REF: 23-02098-OUT

**Location: Begbroke Science Park, Begbroke Hill,
 Begbroke, OX5 1PF**

17 January 2024

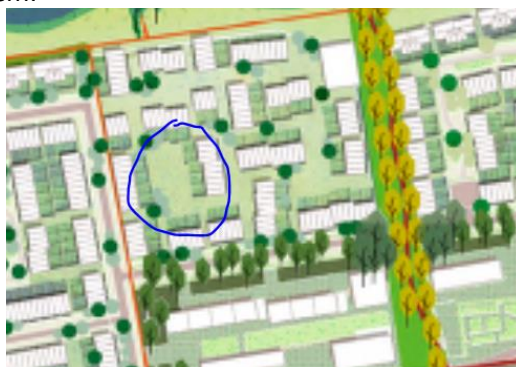
- Parking barns are potentially a highly problematic suggestion in a residential setting, and I strongly urge the applicant to consider this proposal further prior to submission of detailed plans. Parking barns are essentially enclosed car parks or multi-storey car parks that may be very vulnerable to crime and ASB. Should these be included in forthcoming applications, it is imperative that the following issues are addressed in detailed plans;
 - Parking barns may lack ownership due to being remote from the homes that they serve and not under any particular persons’ control.
 - The design of barns may prevent surveillance from the surrounding development, leaving vehicles vulnerable to crime/damage.
 - It should be noted that not all offenders are external to a development, and as such access to a large covered parking area still creates an opportunity for crime, even with CCTV in

place. If an incident happens it could be days or weeks before the owner of a vehicle realises, reducing or removing opportunities for identification and prosecution of offenders.

- How will spaces within parking barns be allocated?
- How will residents be prevented from parking on street outside homes instead?
- How will access be prevented to unauthorised persons, and how would visitor parking work if barns are used? Visitors should not be permitted entry into the barn, and on street parking closer to homes is likely to be used by residents instead.
- How will vehicle tax and insurance work in a publically accessible parking barn, should someone wish to store a vehicle within the barn without tax or insurance? If there were an accident within the barn then this may be a significant legal issue for residents to overcome.
- EV charging equipment theft is a crime on a significant upward trajectory – how will EV charging be managed within a parking barn where surveillance may be reduced?

All parking provision for the development must comply with the requirements of Secured by Design – Homes 2023 (section 16), and the requirements set out under “Parking” in my detailed guidance below.

Road layouts

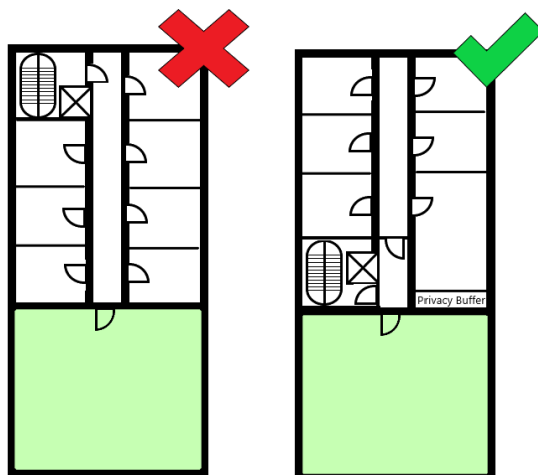
Road layouts must have sufficient engineering to ensure compliance with speed limits, without the need for police enforcement.
